Noise Feasibility Study  
Proposed Mixed-Use  
Development  
The Gateway Centre  
Highway 124 & Poplar  
Sideroad  
Collingwood, Ontario

November 27, 2025  
HGC Project #: 02400511

This study has been revised to reflect an updated site plan prepared by Richard Ziegler Architect Inc. dated November 6, 2025 and to address peer review comments from R. Bouwmeester & Associates dated November 7, 2022 and September 25, 2025. Responses to the peer review comments are included in Appendix D.

Figure 2 - Proposed Site Plan Showing Prediction Locations

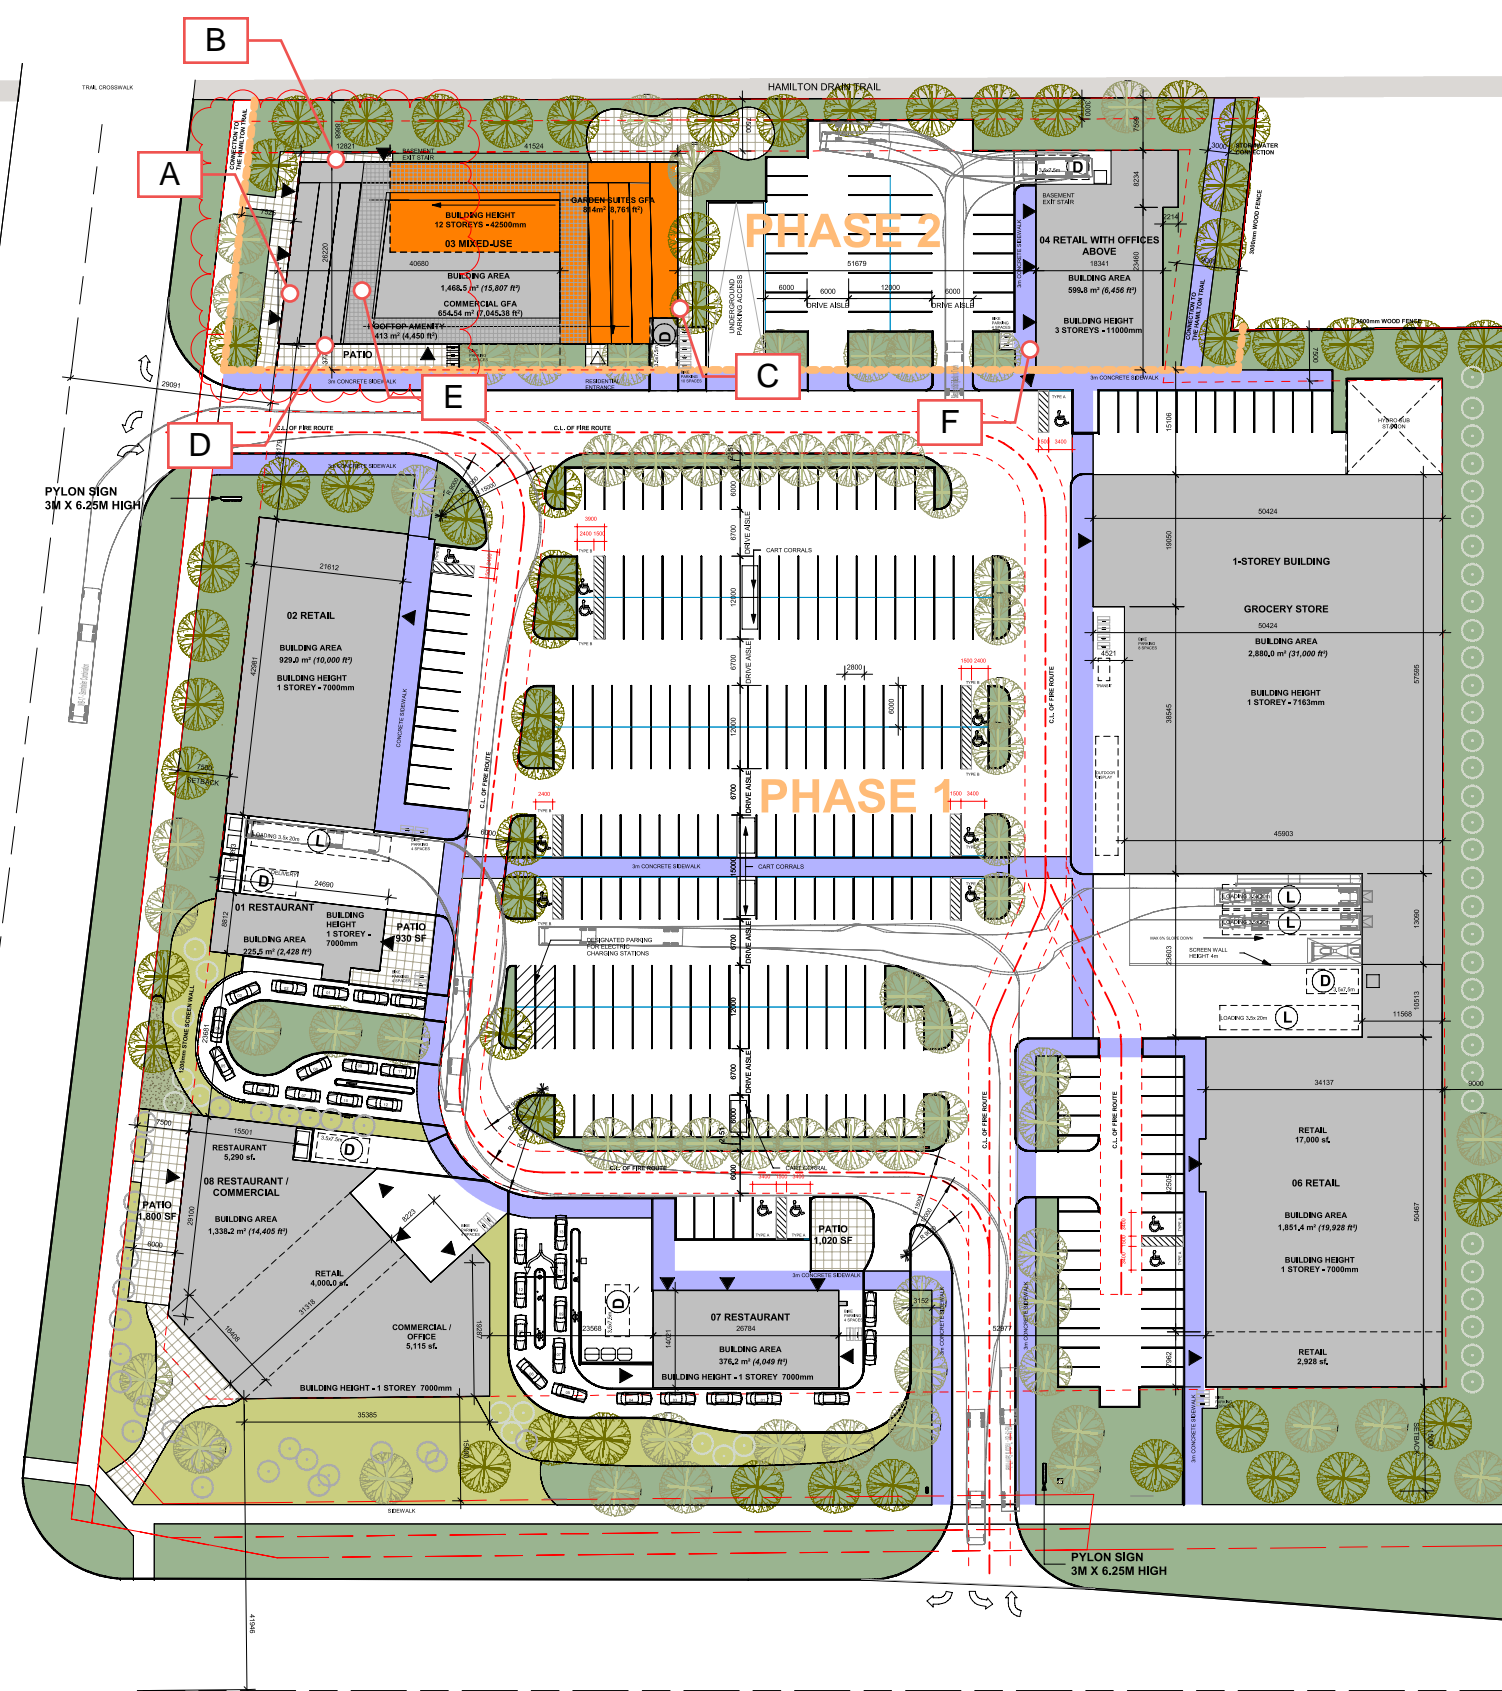
4. Figure 2 and the zoning map in Appendix 'A' have been 'cut off'. Please correct.

*The figures in the revised report have been scaled to letter size.*

**Figure 5a - Maximum Predicted Daytime Sound Levels from Proposed Stationary Noise Sources On Existing Sensitive Uses (Without Mitigation)**

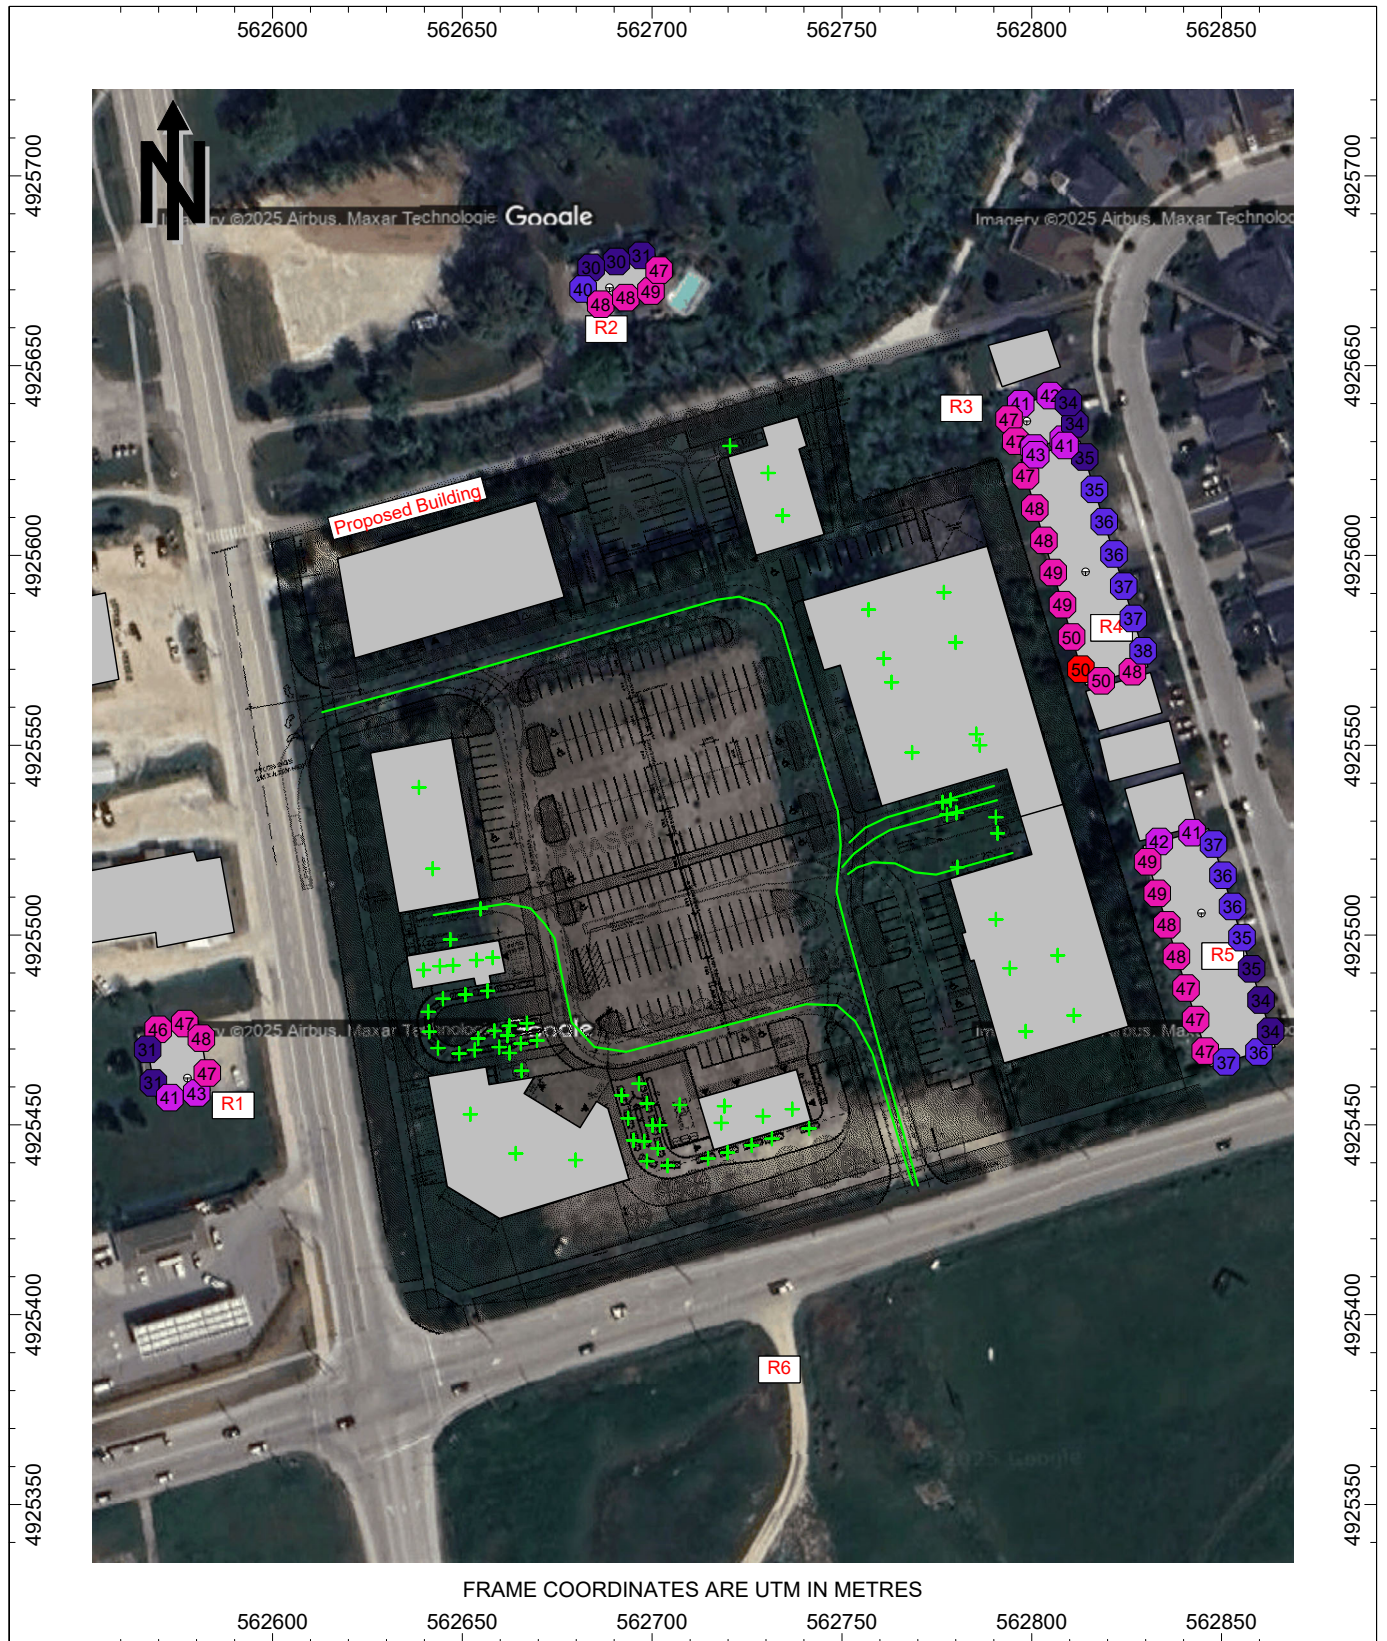
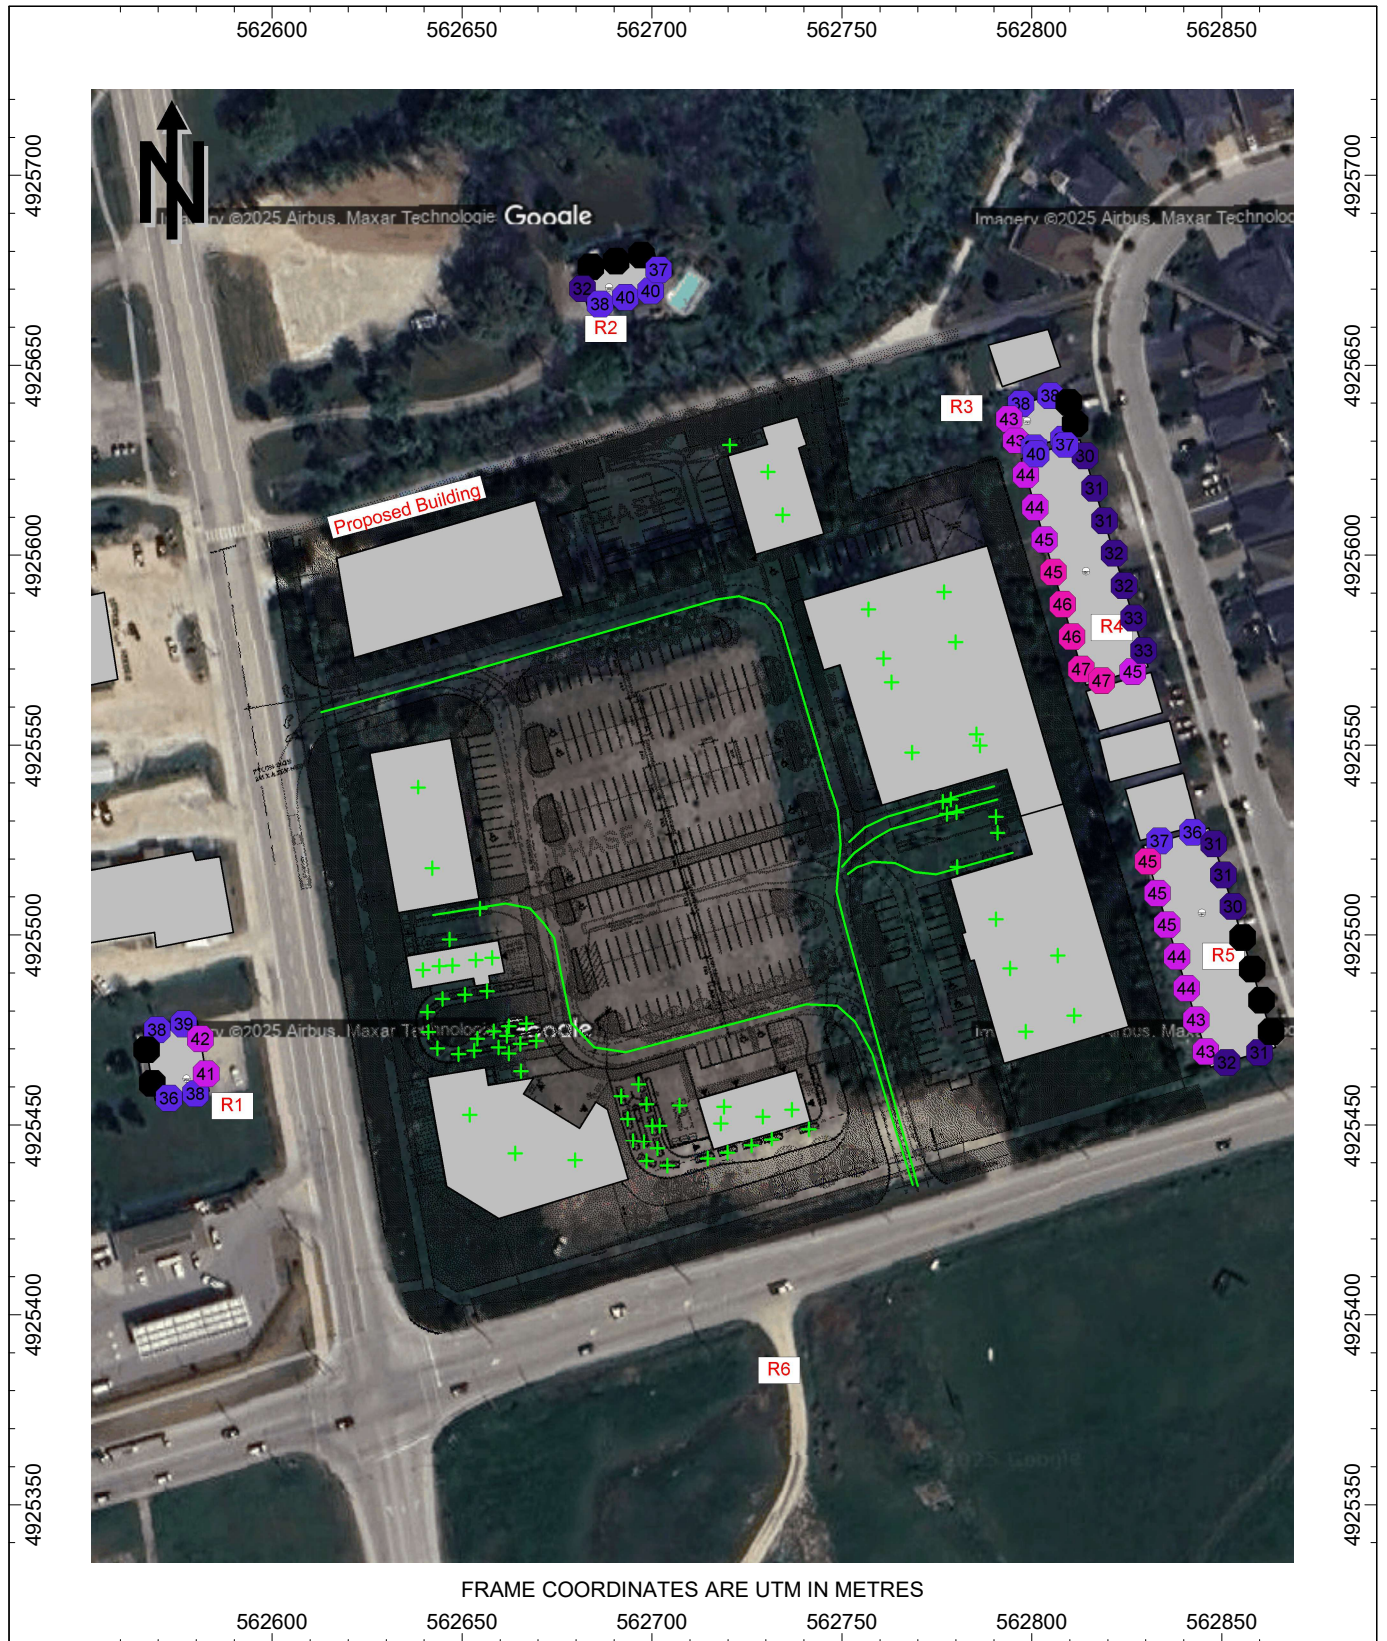
5. Please provide sample Cadna-A inputs/outputs to support the results shown in Table III and Figures 5a and 5b.

*Sample Cadna-A inputs/outputs are provided in Appendix C of the revised report.*
